# Access Compliance Report Public Rights-of-Way (Curb Ramps)

Main Street: **RASTRO\_ST** Cross Street: **NACIENTE\_ST** Location: **E**

ADA ID: **RPRK211116141402** Ramp Type: **Type 4 - Parallel** Initial Pass/Fail: **Fail** Overall Compliance: **No** Severity Score: **30**

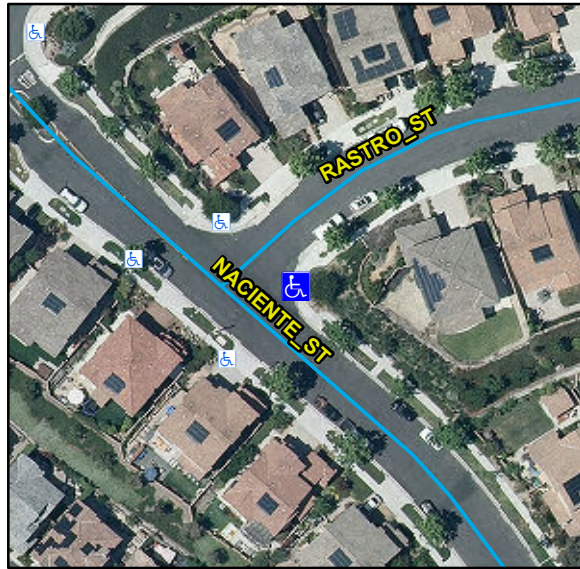
| Compliance | Description                   | Data              | Compliance | Description                   | Data       |
|------------|-------------------------------|-------------------|------------|-------------------------------|------------|
| <b>No</b>  | Ramp Run Slope LT (%)         | <b>12.3</b>       | <b>Yes</b> | Ramp Run Slope RT (%)         | <b>4.4</b> |

**Remove & Replace Curb Ramp With Two New Directional Ramps or Equivalent.**
